THIS PRINT IS THE PROPERTY OF ITS CORP. IT SHALL NOT BE COPIED WITHOUT PERMISSION.				TITLE			
MATERIAL				BLOCK DIAGRAM 600W TRAY (1227-1300)			
FINISH				DWN	RFB	5/5/94	DWG. NO.
				CHK	DWR	5/5/94	1227-3300
				REL	DWR	5/5/94	4
				SCALE--- SHEET 1 OF 1

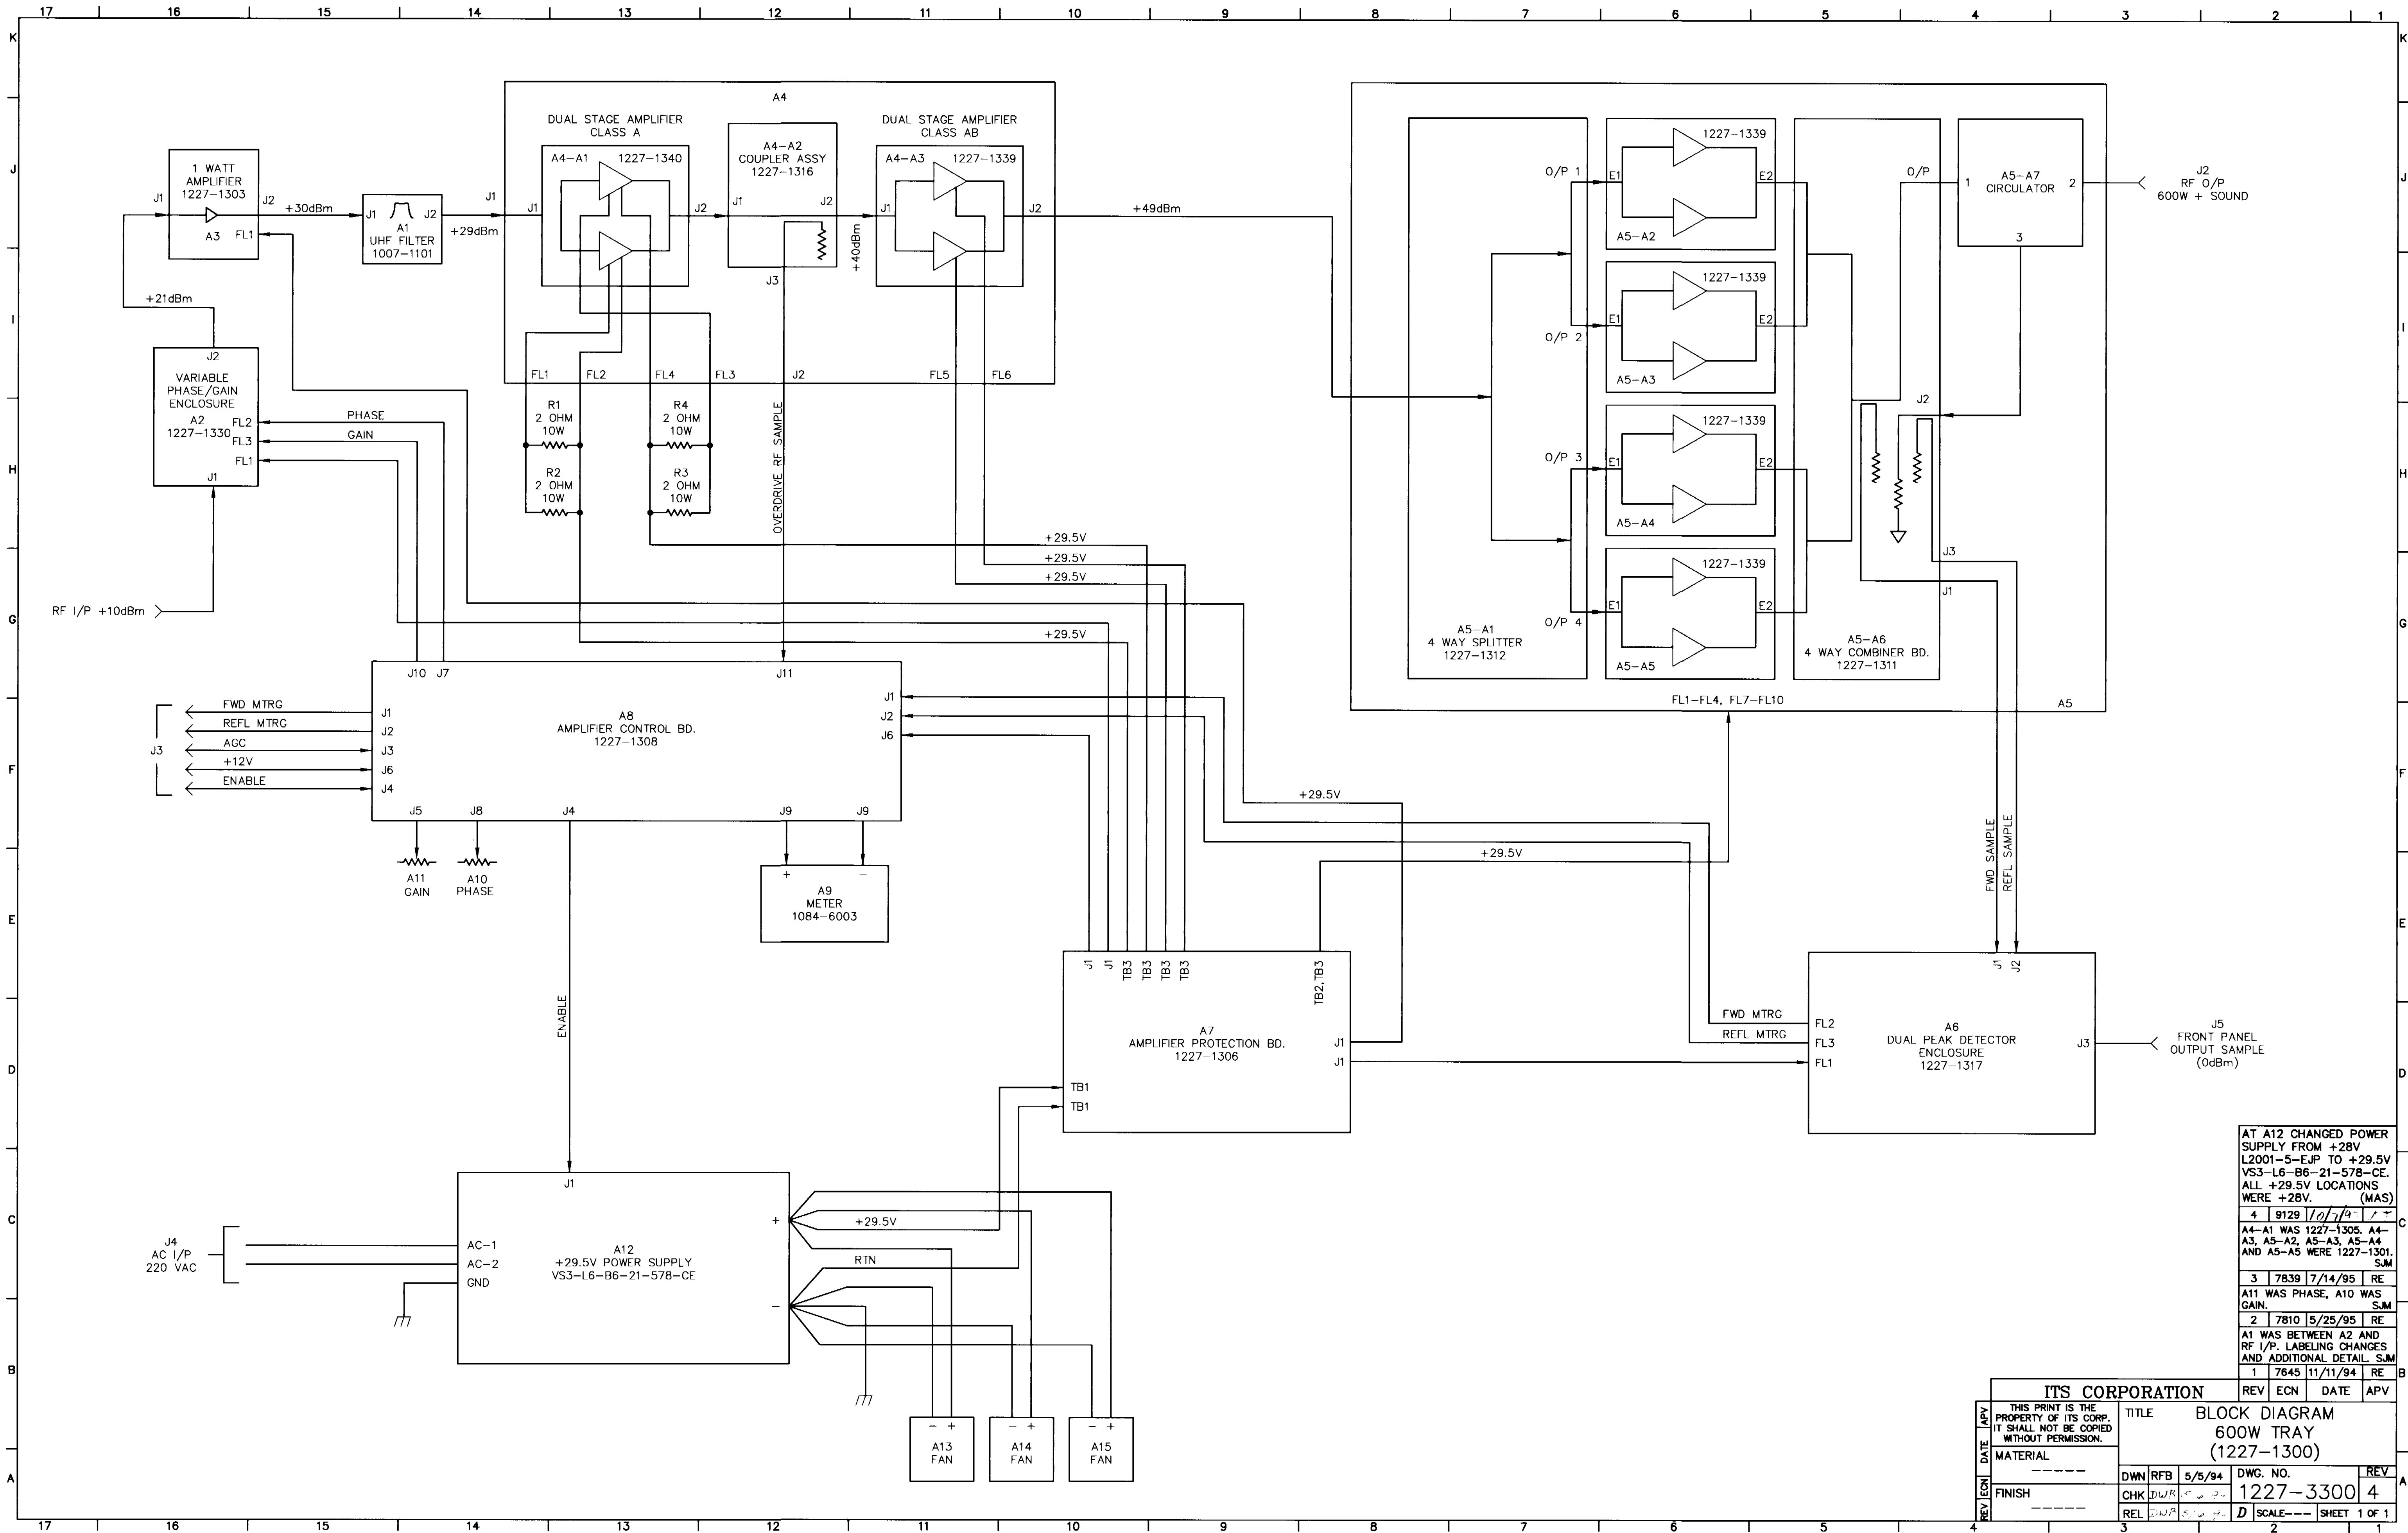
AT A12 CHANGED POWER SUPPLY FROM +28V L2001-5-EJP TO +29.5V VS3-L6-B6-21-578-CE. ALL +29.5V LOCATIONS WERE +28V. (MAS)
